Traffic Calming (Speed Humps) Renault Crescent

Date: June 26, 2024

To: Etobicoke York Community Council

From: Director, Traffic Management, Transportation Services

Attachment 2: Speed Hump Locations Plan Renault Crescent, Chapman Road - Royal York Road

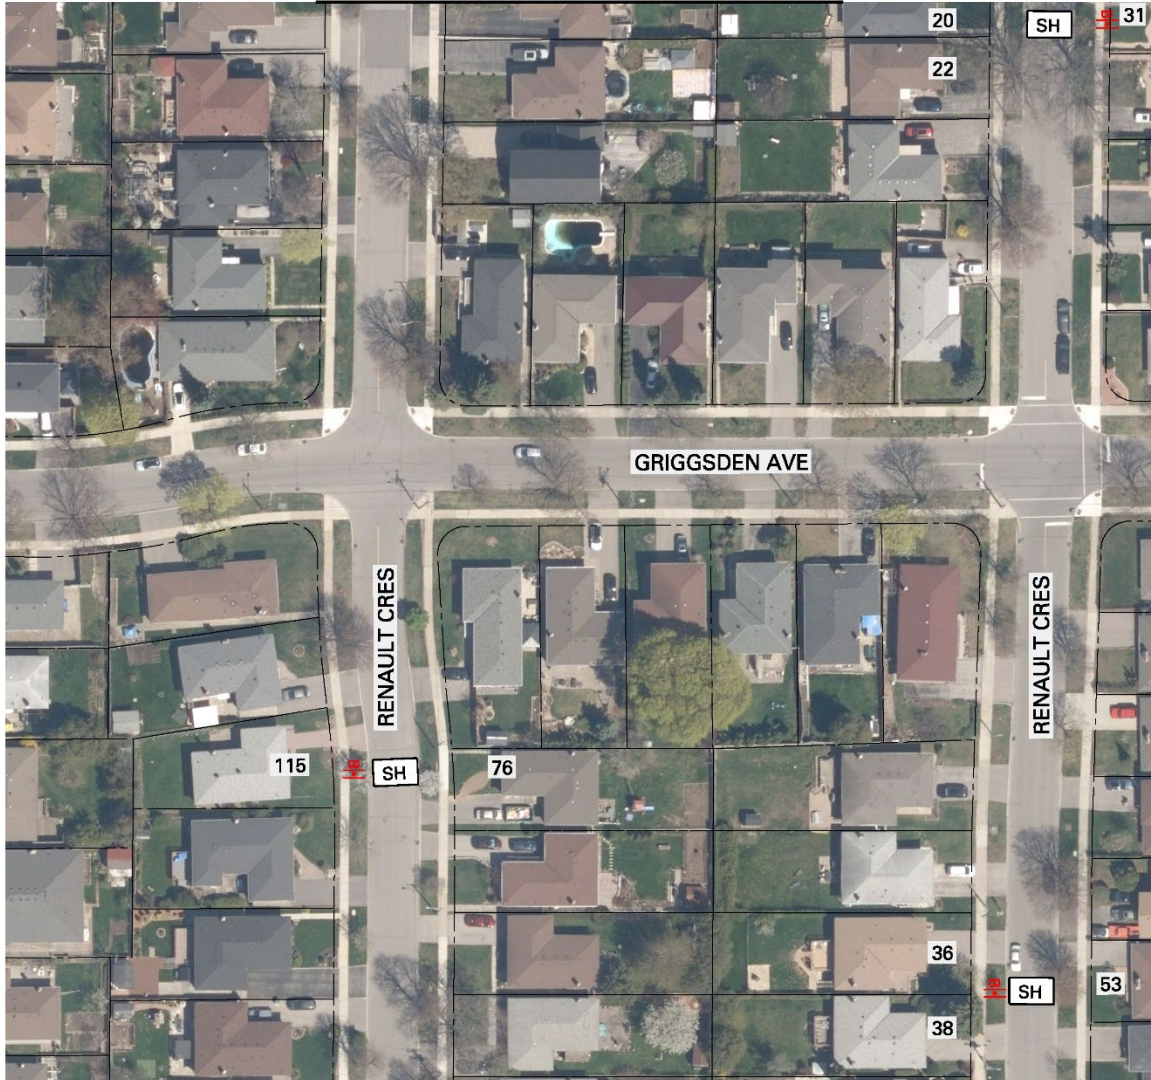
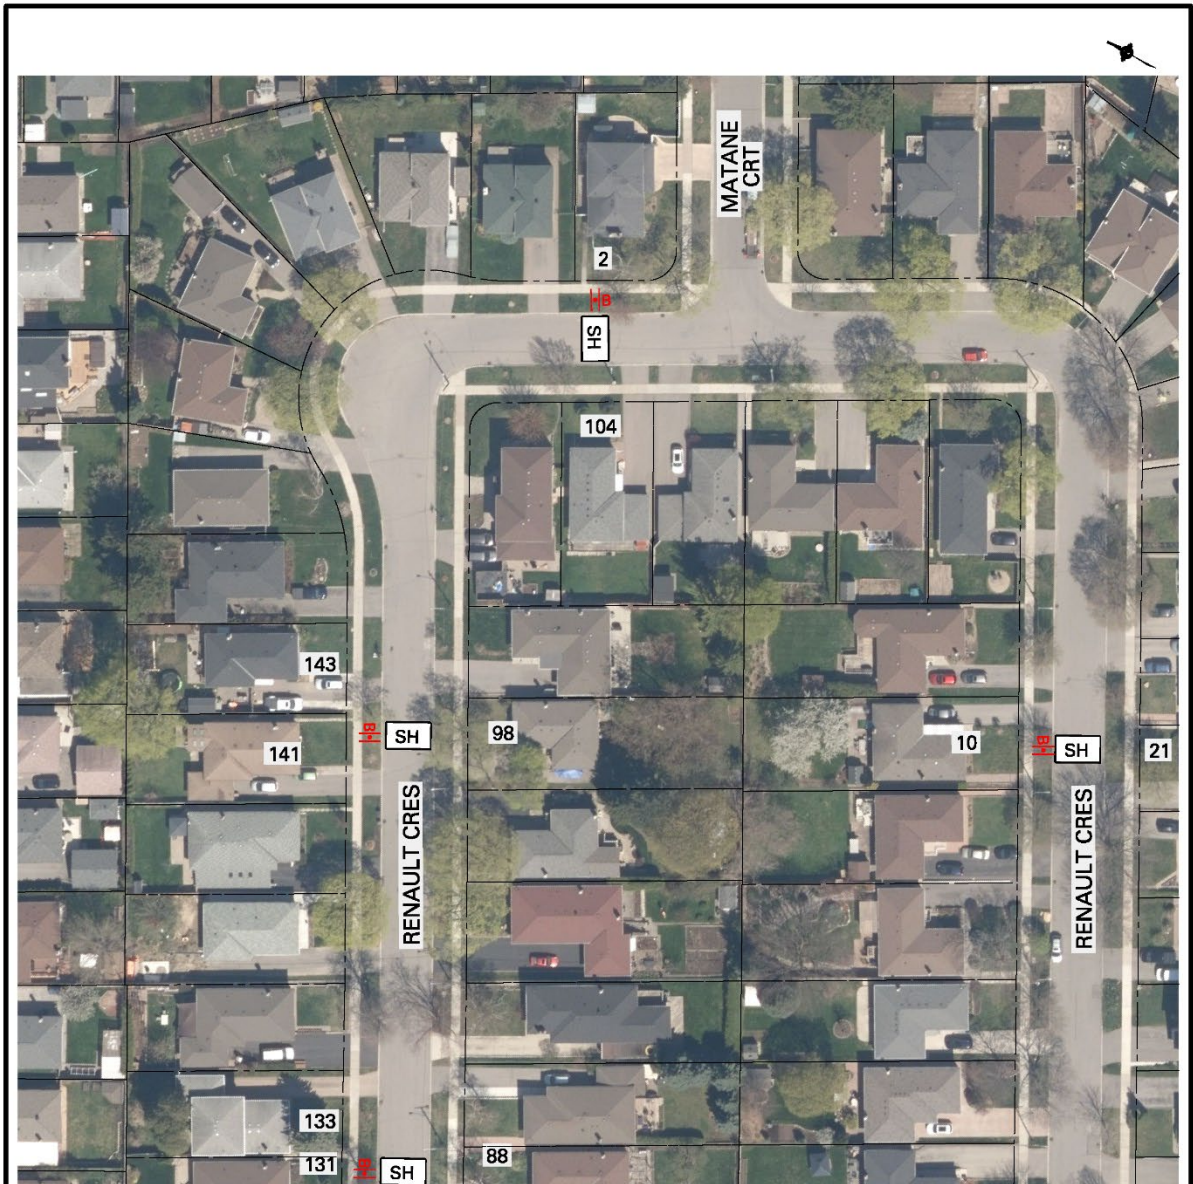
Toronto Fire Services does not support this proposed speed hump installation as it may negatively impact service delivery. The physical restrictions imposed by speed humps have a greater impact on fire vehicles. Response time increases with every obstacle encountered responding to any emergency incident and the cumulative impact of several speed humps can increase responses times.

Toronto Fire Services is supportive of initiatives that improve safety for all citizens of and visitors to the City of Toronto. However, careful consideration must be given to accepting a delay to emergency response vehicles as a compromise to combat the risks presented by all vehicular traffic. Our recommendation is that non-physical measures be considered and evaluated to determine if desired results can be obtained without imposing a physical obstacle to emergency vehicles.

The installation of speed humps on Renault Cres will impact response and transport times for residents that reside on the roadway speed humps are installed. Impacts may extend to community members if Renault Cres serves access to other roadways. It is important that the applicant understands that the installation of traffic calming devices will reduce the speed that emergency vehicles travel when responding to emergencies on roadways where they are installed.
